Product Change Notification (PCN)

PCN Number	510909	Date Issued	November 09, 2021
Reason for Change	Packaging Method/Quantity Changing		
Change Type Description	This letter is to inform you that the part(s) referenced in this notice will undergo packaging specification changes that may include a new Delivery unit, packaging size, changes to the label or packaging material. No changes will be made to the product as a result of this change.		
Reason for Short Notice	Update Previously Issued Change Notice		
Assessment of Change	Drop test approved		
Internal Molex Qualification Date	October 09, 2021		
Sample Availability Date (Changed Part)	October 09, 2021		
Planned Implementation Date	December 01, 2021

Before Change

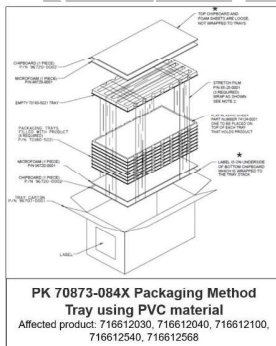
- As a valued customer, we wanted to notify that:
 - Molex implementing changes on EBBI packaging material and method as part of the product transfer strategy from Molex Nogales to Management of Molex Singapore
 - Tray material changed from PVC to APET (General design of the trays shall remain the same)
 - Carton Box, Cardboard, tape and others packaging material shall be localized to Management of Molex Singapore
 - Details of the packaging method change shall refer to the illustration below
- No impact to product fit, form and function
- Drop test reports available upon request after the date shown above
- Part Number Impacted refer to attached impacted parts list
